**From:** "Larry Harmon" <lharmon@safetylight.com>  
**To:** "John Jankovich" <JPJ2@nrc.gov>  
**Date:** 4/23/03 1:36PM  
**Subject:** RE: Request for Additional Information

From: John Jankovich [mailto:JPJ2@nrc.gov]  
Sent: Monday, April 21, 2003 12:27 PM  
To: lharmon@safetylight.com  
Cc: Nima Ashkeboussi; Ujagar Bhachu  
Subject: Request for Additional Information

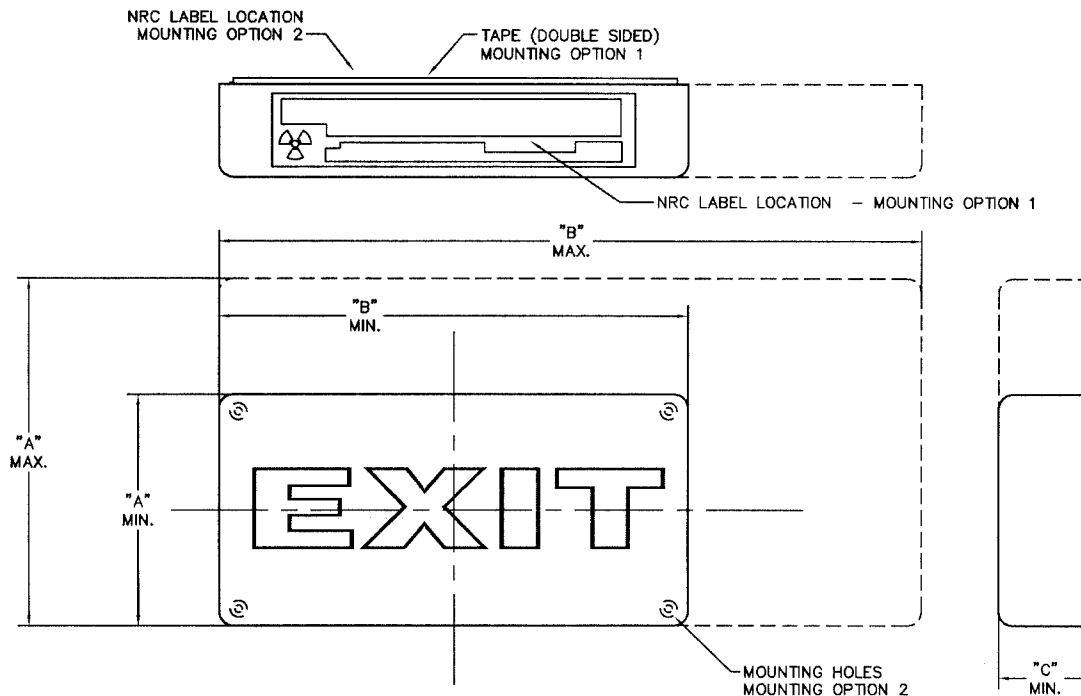
1. Provide an electronic version of a generic drawing for your exit signs. For example, the drawing of Model AC/6 can be generalized by removing the dimensions and substituting with the letters "a, b, and c," and we will add a table to reflect these dimensions for the model series AC/2 through AC/29.

Hi John. I am attaching to this email the items to satisfy 1 and 2 below. The devices are listed on Self Powered Lighting license 1406-1611 GL. These devices should be added to Safety Light Corporation registration certificate NR-0579-D-112-G. Please disregard model 618-5790. It was my error. It is an obsolete part. If you need anything else please give me a call.
